DATE: June 25, 2007

RE: *Design Change to Push-in-Seat (06256) in GX Unloader*

New Design for Push-in-Seat

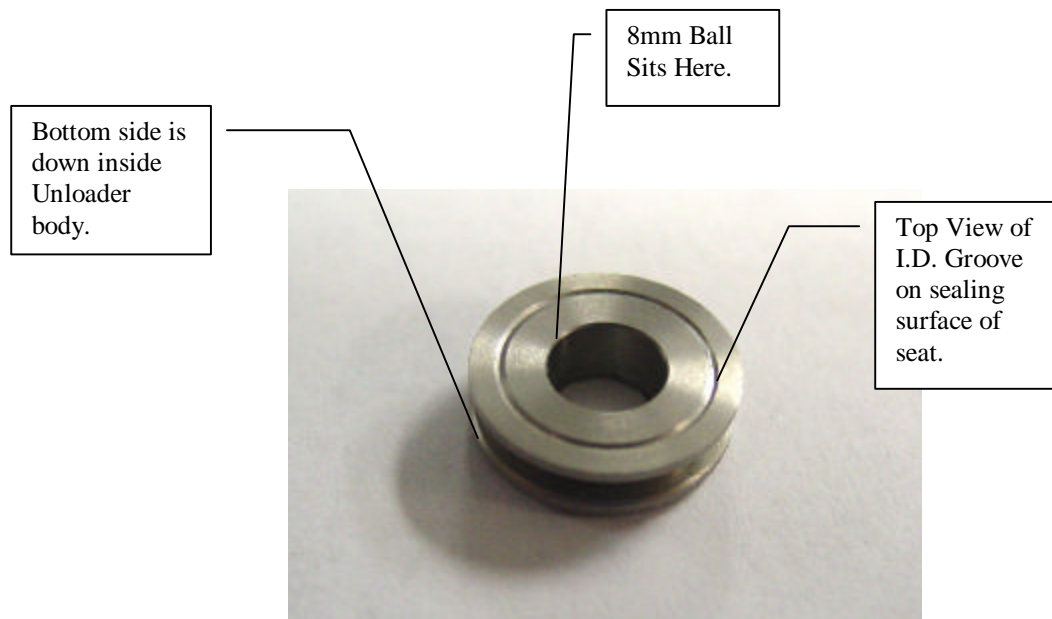
The purpose of this Technical Bulletin is to inform Giant Industries Staff and it's Customers of a Design Change for the Push-in-Seat (06256). This part is seen inside the Unloader of the GX series of pumps. The reason for this change was to better identify which way the seat should be pushed into the body of the Unloader. As you can see in the graphic below the seat now has a machined groove in it's face. This groove should be seen when the seat is assembled into the Unloader properly. If the groove is not seen then the seat is in backwards and the Unloader will not operate properly. The piston will not unseat the ball as the system goes into bypass, causing abnormal pressure spikes. These pressure spikes can cause serious damage to the pump and possibly injure the operator. Make sure the customer has a safety valve on all system.
